# 2.0 SOLAR ACCESS

# 3.0 BUILDING A ROOFTOP PLANT

# S75W ADJUSTMENTS SCHEME COMPARISON PLAZA

PROPOSED ROOF PLANT PLAN

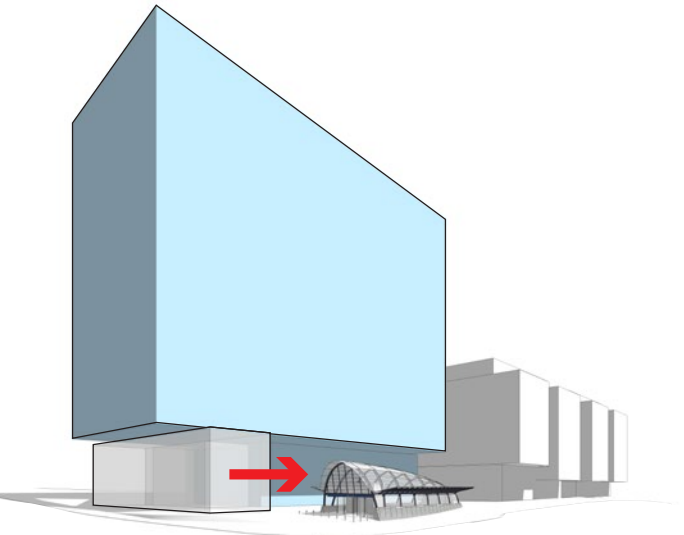
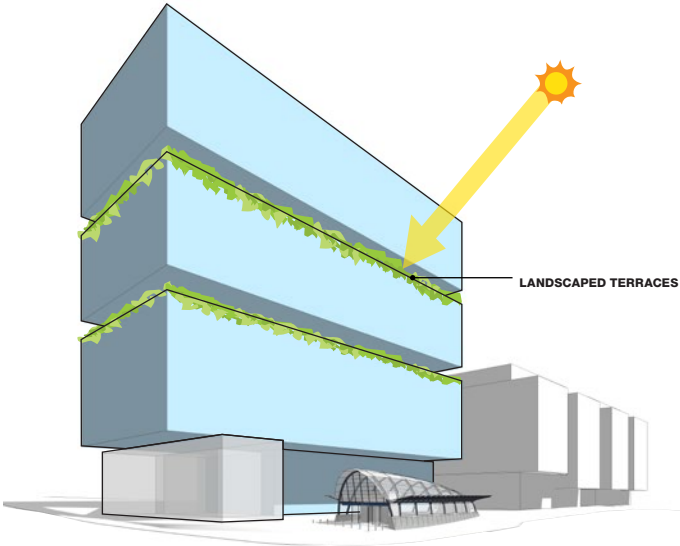
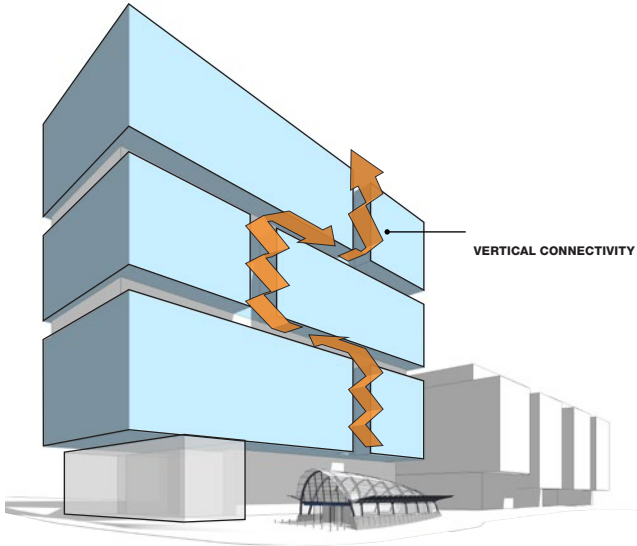
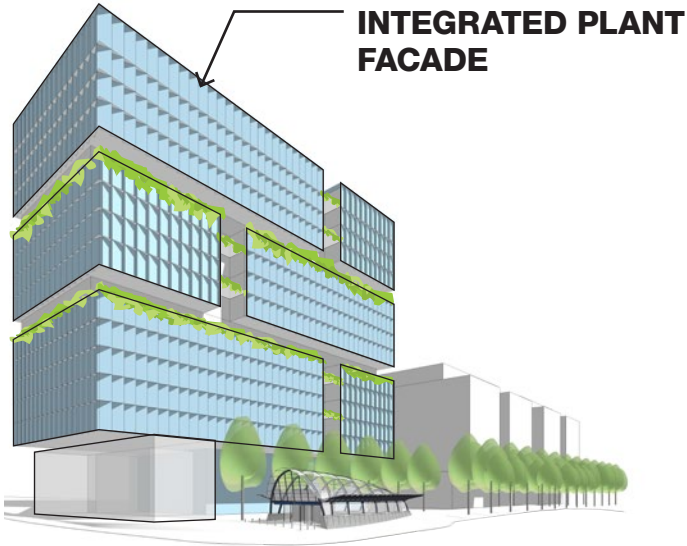
**Building A**  
1. Review the extent of rooftop plant of Building A, including options to incorporate setbacks to the northwest, northeast & southeast.

The plant level has been designed to accommodate required spatial area for mechanical plant and other base building servicing requirements. Reducing the extent of plant through introduction of setbacks will no longer meet the size requirements.

The building massing concept has been studied and the optimum architectural massing outcome comprises a series of stacked volumes that emphasise & articulate the building through landscaped external terraces & expressed vertical connectivity through the building.

The plant facade design is to be fully-integrated into the building's architecture and will become the upper level of the topmost volume. This proposal uniquely disguises unsightly plantroom level when viewed from afar, whilst still achieving the required functionality of the building's servicing requirements.

# 3.0 BUILDING A GROUND FLOOR SETBACK FROM STATION ENTRY

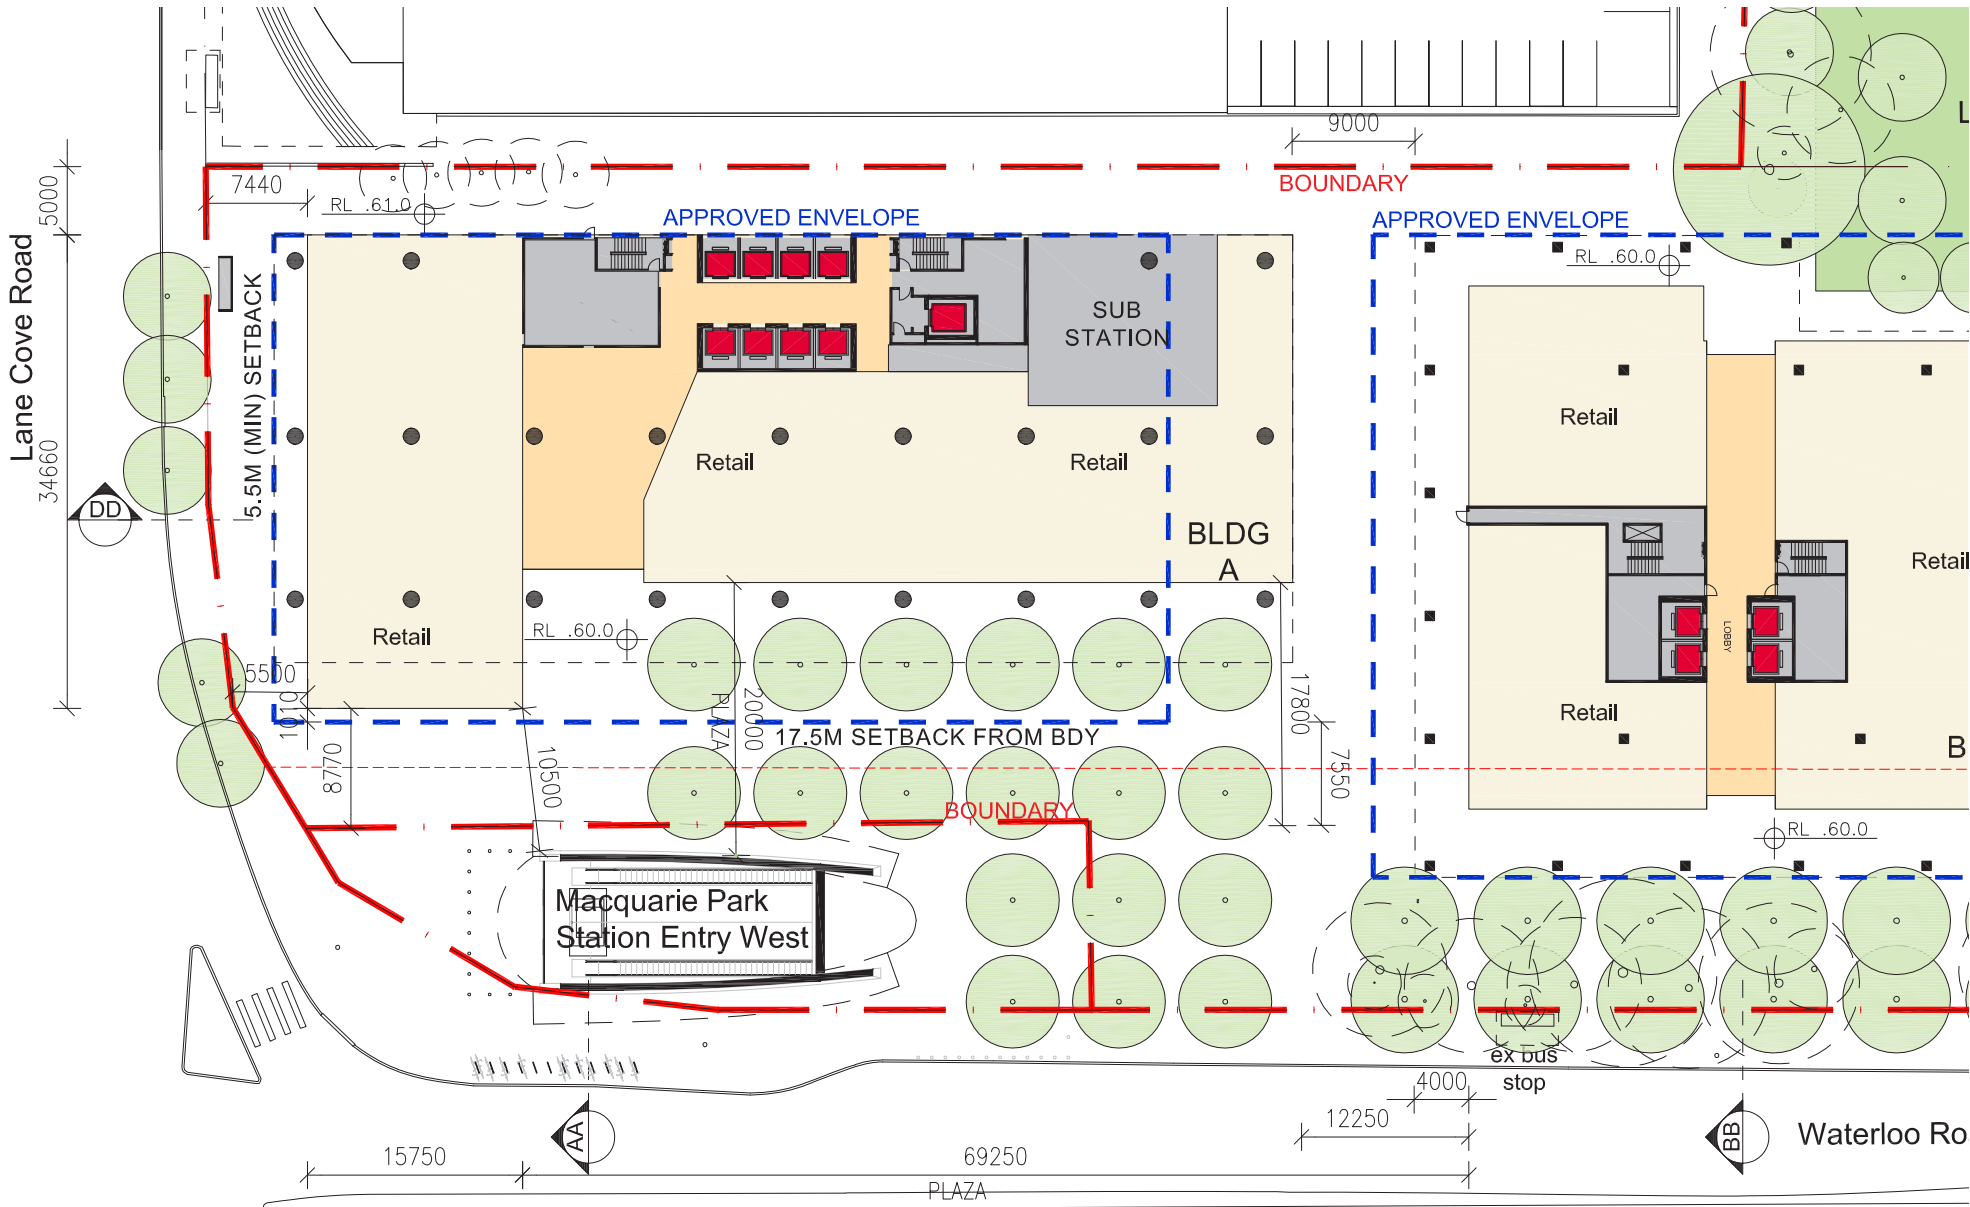
**Building A**  
2. Provide dimensions of the setback of the ground floor protrusion from the station entry and site boundary. Provide a view of this aspect of the building to show the area for the pedestrian movement.

Refer to below plan and image.
